Community Feedback for Proposed Development:
84-104 Plains Road East and 990 Glenwood Avenue
Miura Development Group Inc.

This letter highlights the primary concerns of the undersigned community regarding the proposed development at 84-104 Plains Road East and 990 Glenwood Avenue (“100 Plains Rd E.”) and densification of our neighbourhood.

Figure 3: Development concept at 53-71 Plains Rd E & 1025 Cooke Blvd (as presented to OLT)

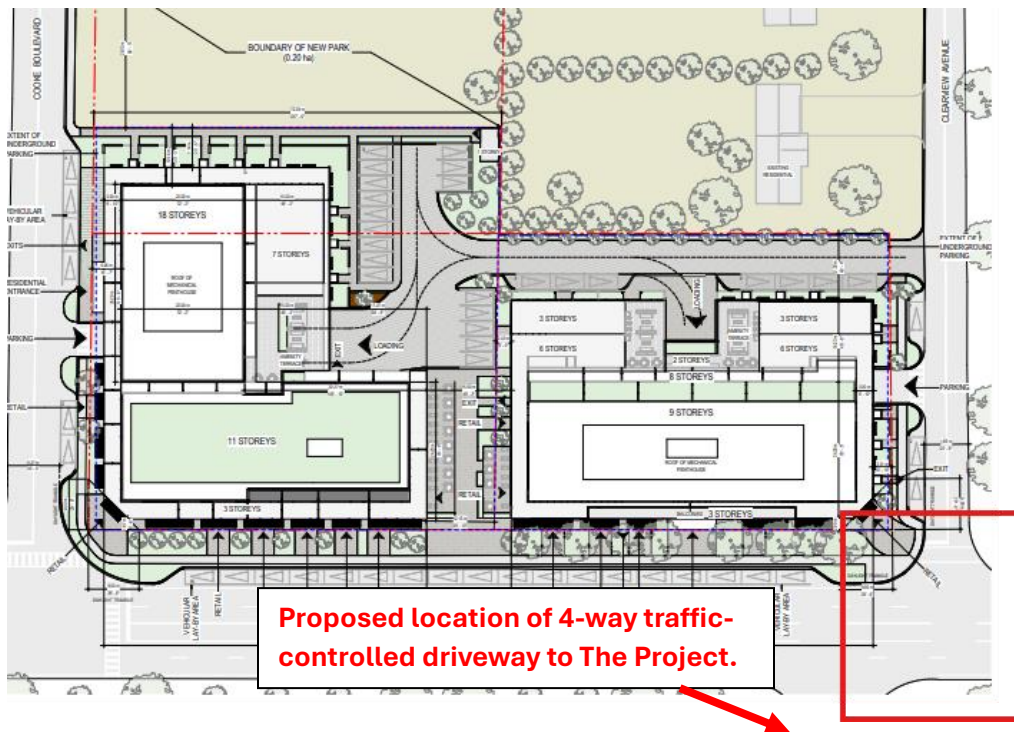
- The **only** driveway access to 100 Plains Rd. E. should be from Plains Rd. It is recommended that this driveway access should be from a 4-way controlled traffic light at the intersection of Clearview Ave and Plains Rd E. This access point aligns with west end of the 100 Plains Rd. E. site and the main access point on the development at 53-71 Plains Rd. E, 1025 Cooke Blvd (Figure 3).

- Note: Failure to align the driveway of 100 Plains Rd. E. and the main access point at the 53-71 Plains Rd E & 1025 Cooke Blvd development would lead to three busy, uncontrolled intersections within 300 metres

Figure 4: 100 Plains Rd. E. is among the furthest properties from the “height peak” in the MTSA and is embedded within an existing low-rise residential neighbourhood

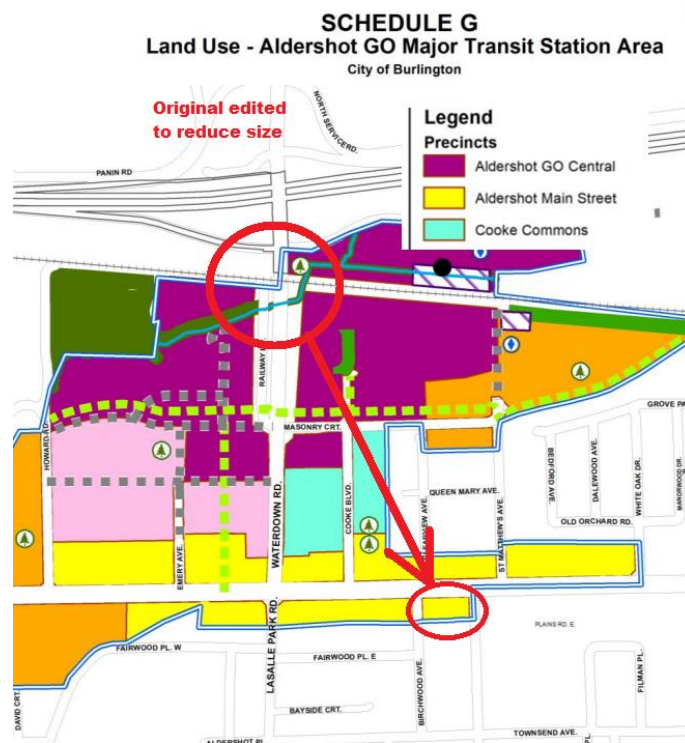
- 100 Plains Rd. E. is among the furthest properties from the “height peak” or highest density area of the Aldershot MTSA, and among the closest properties to existing residential (Figure 4). Given the approved development projects and target density near the Aldershot GO, there is not a reasonable need for maximum density on land adjacent to existing residential.
- 100 Plains Rd. E. should have density closer to the minimum thresholds given the more intense density that will occur in other parts of the Aldershot MTSA – namely, Aldershot Go Central, Cooke Commons and Emery Commons.

- 100 Plains Rd. E. should have density ratios closer to 1085 Clearview given the similar proximity to existing residential homes.
- The proposed floor plan (65% 1-bedroom or less) should be restructured in a manner that is most desirable for young families as this building is within fantastic school catchments. This would mean an increase in the proportion of 2- and 3-bedroom units.
- Lower height and deeper building form may allow for reasonable floor plan (and cheaper construction costs) without over densifying the site.
